(FINAL) QUESTIONS + ANSWERS – Questions submitted through October 4, 2019

QUESTIONS + ANSWERS – Questions submitted through September 27, 2019

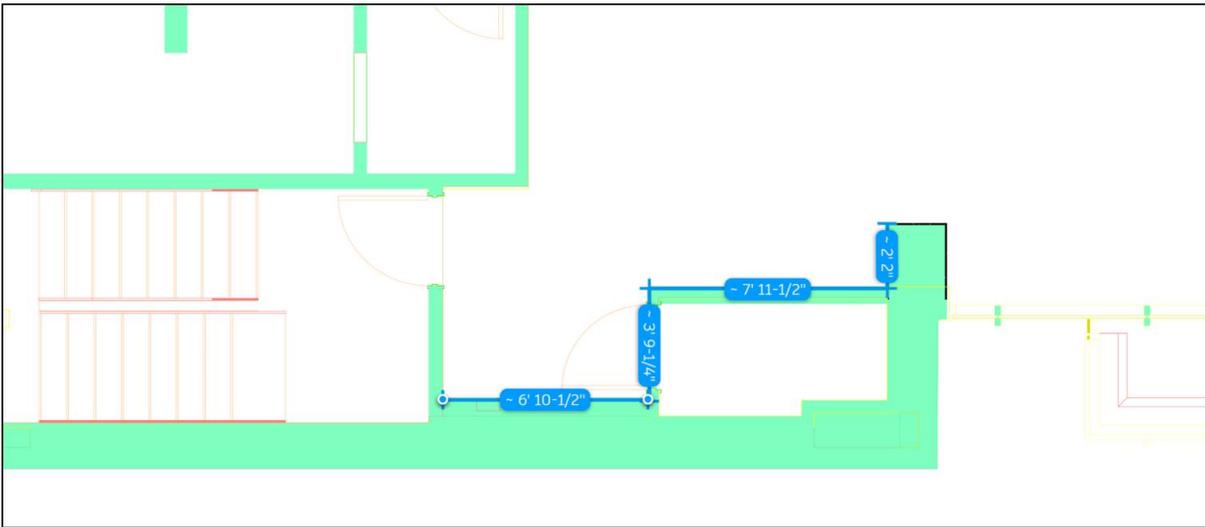
Q: Does the Learning Commons need to be directly off of elevators? Or can it be pushed back further into the space if it makes sense for our concept?

A: It does not need to be directly off the elevators. You may also want to review the Q+A from 9/27/19 regarding a Learning Commons question.
